TECHNICAL BULLETIN  
K185NAS1  
16 AUG 2013

Service Action: Stowage Box Lid

**F-TYPE (X152)**

**Model Year:** 2014  
**VIN:** K00317-K03880

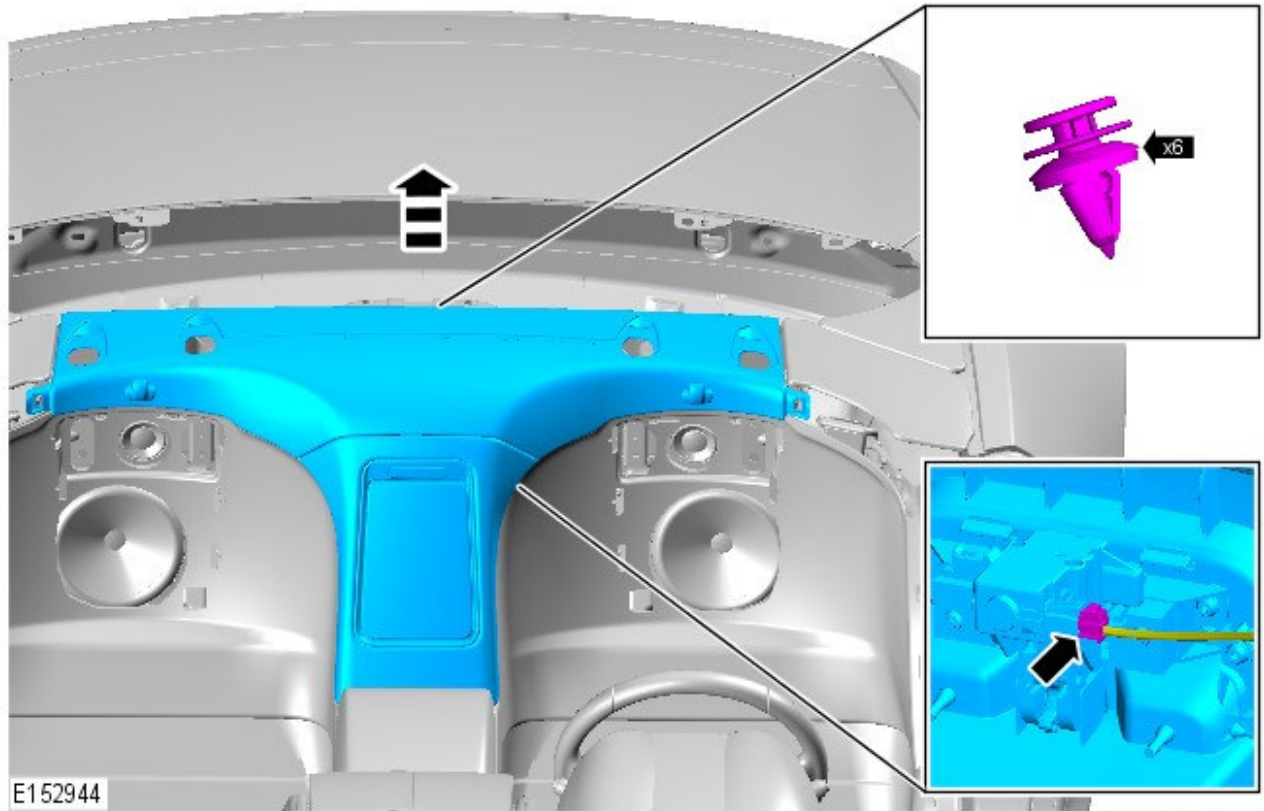
6. Remove and discard the two (2) felt pads.

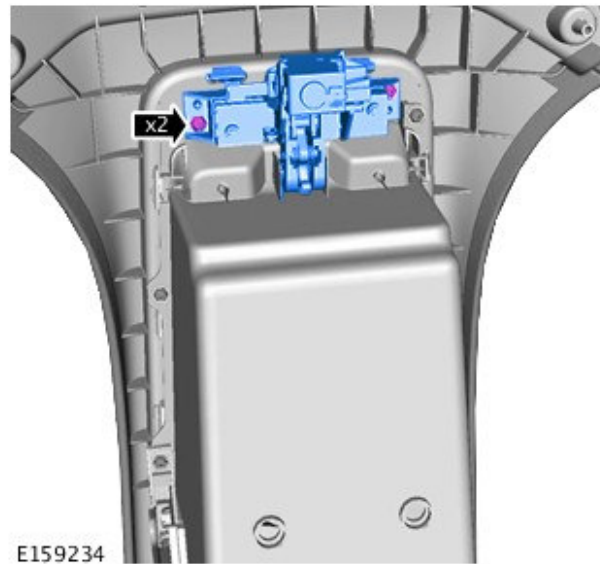
**8.** Undo the fixing; remove and discard the latch:

- Install the new latch
- Tighten fixings to 1.0 Nm +/- 0.2 Nm.
